OPERATING INSTRUCTIONS FOR NEUMANN CONDENSER MICROPHONES U 47/U 48 AND ACCESSORIES

Conversion of Neumann U 47 and U 48 microphones to nuvistor tubes

(nuvistor 13 CW 4 instead of tube VF 14)

U 47-960-02-01

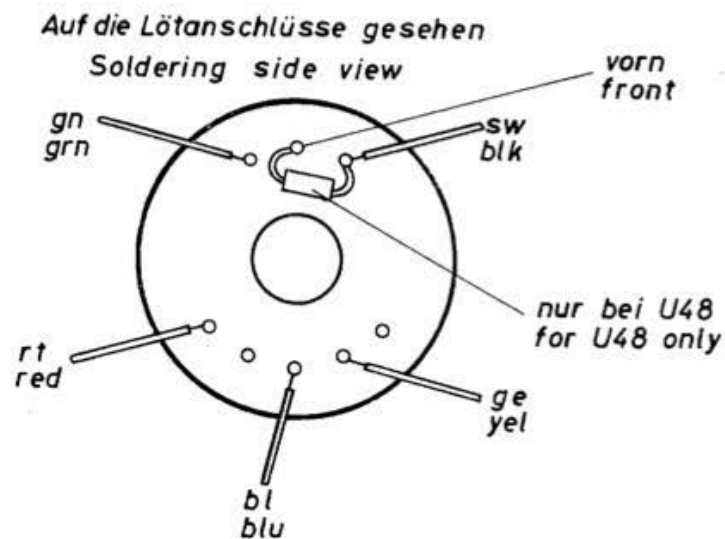
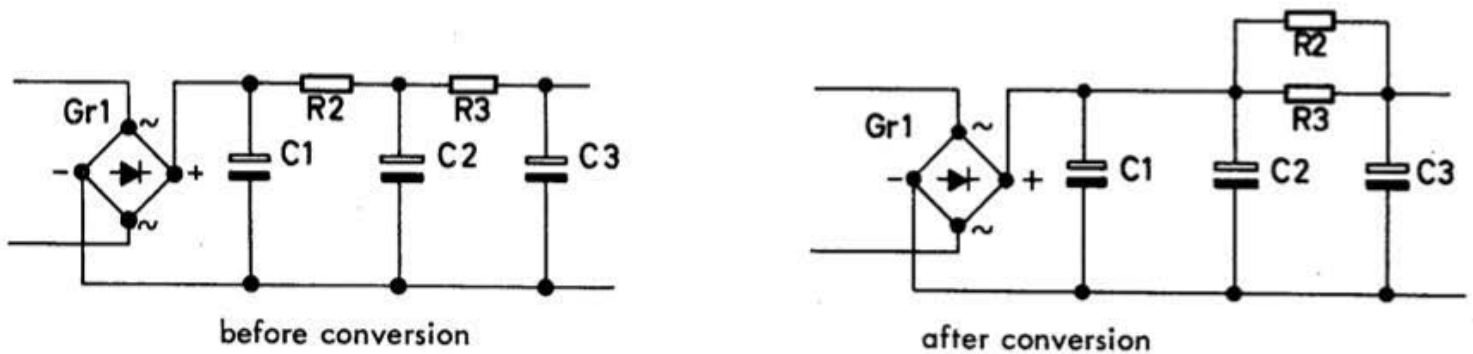
1. Remove VF 14.
2. Remove the leads (red, blue, yellow, green, black) from the tube holder (at U 48 remove also 29- Ω -resistor.).
3. Remove the tube holder after unscrewing six screws in the three bars.
4. Two of the three plastic holders supplied have to be inserted into the screw holes.
5. Put the AR 47 upside down into these holders and fix it by inserting the third plastic holder. (The AR 47 side with three soldering points shows towards the front of the microphone.)
6. Resolder the leads according to the sketch below (at U 48 resolder also the 29- Ω -resistor).
7. Insert nuvistor 13 CW 4 into the socket.

The NG pwr supply must have a small change of wiring due to the greater heater current required by the nuvistor.

- a) Replace resistor R-2 (1 k Ω power resistor coming from + terminal of rectifier) by a solid wire connection between the first two electrolytic capacitors.
- b) Install this same R-2 in parallel with R-3 (an identical resistor next in the RC filter chain), thereby making its total resistance value 500 Ω .

NG power supply schematic:

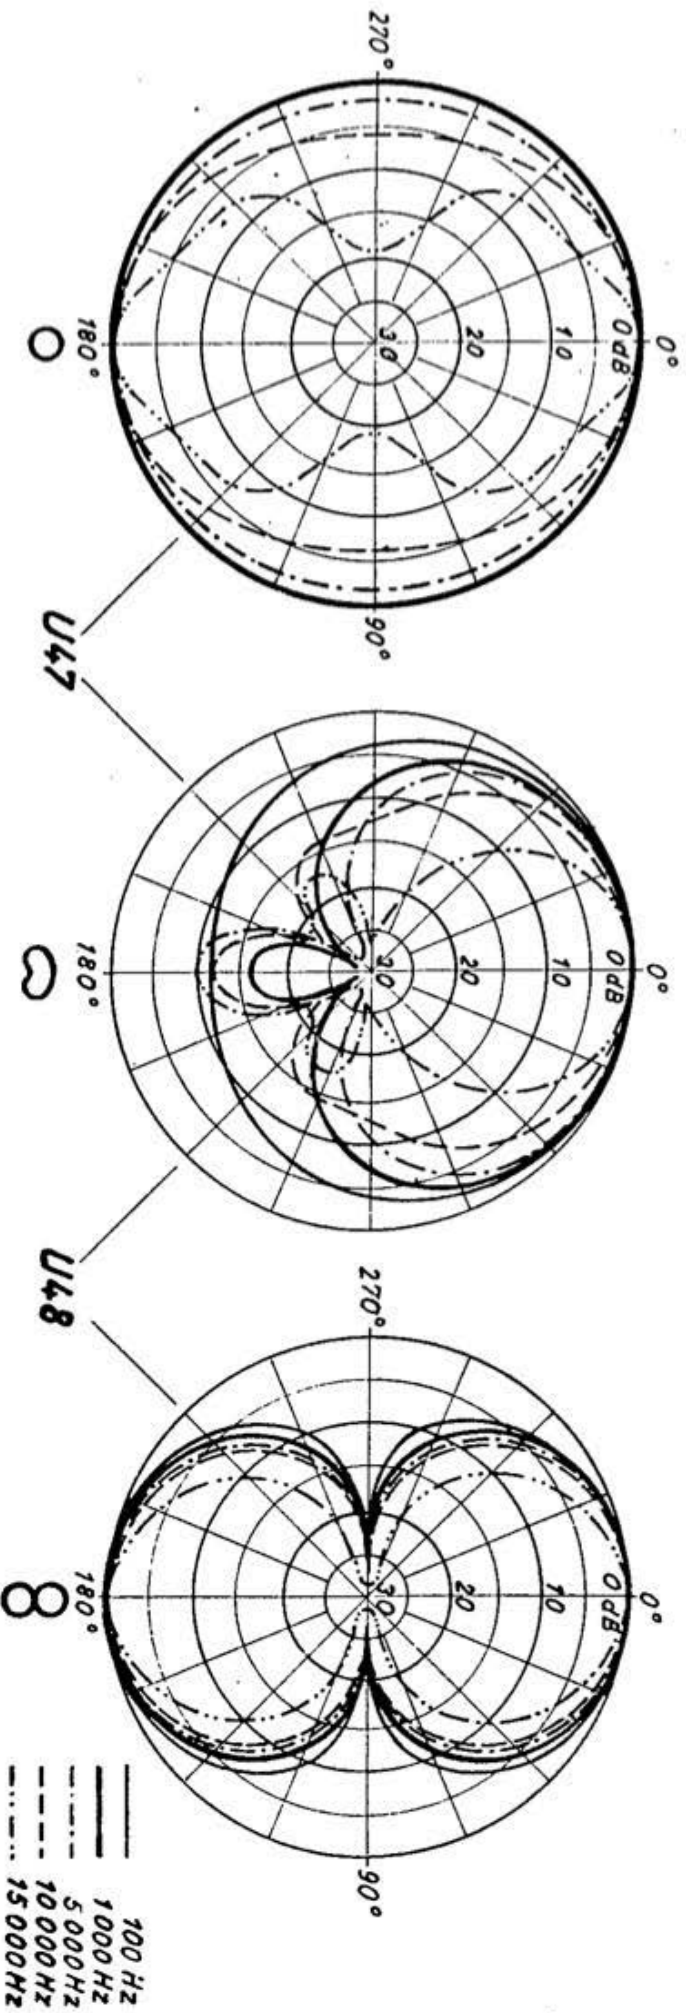
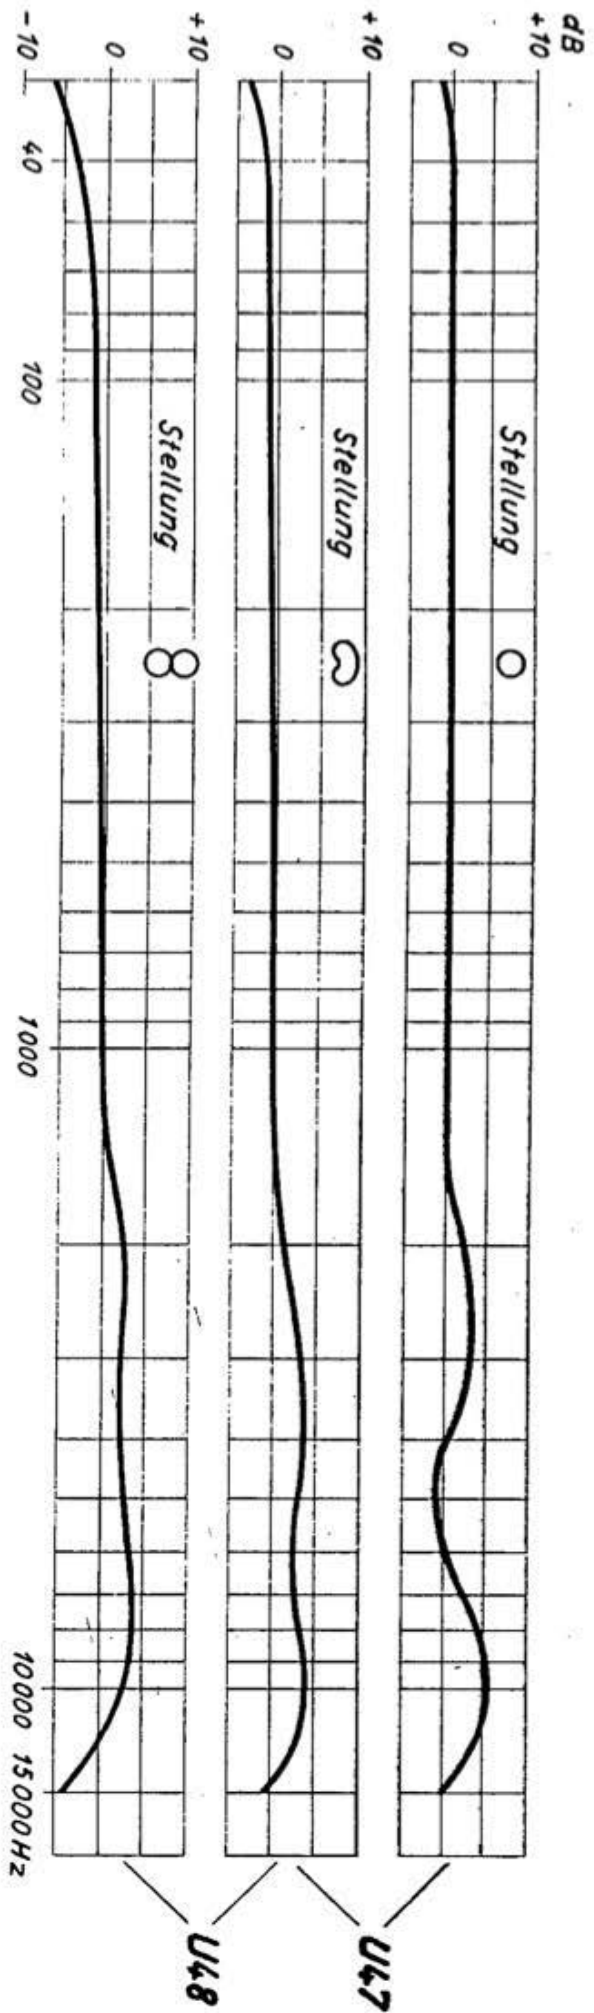
Should you now have some microphones converted and others unconverted, the power supplies and microphones must be marked to prevent confusion.

Should you desire complete interchangeability of converted and unconverted microphones, you may wish to do the following:

- Convert all your power supplies as described above.
- Install in those U 47 / U 48 microphones still equipped with the VF 14 tubes, a 1500 Ω 3 W resistor directly at the back of pin 5 (B+) terminal of the microphone base connector in series with the red lead.
- Remove this resistor at any time that you subsequently convert to the nuvistor adapter in these microphones.
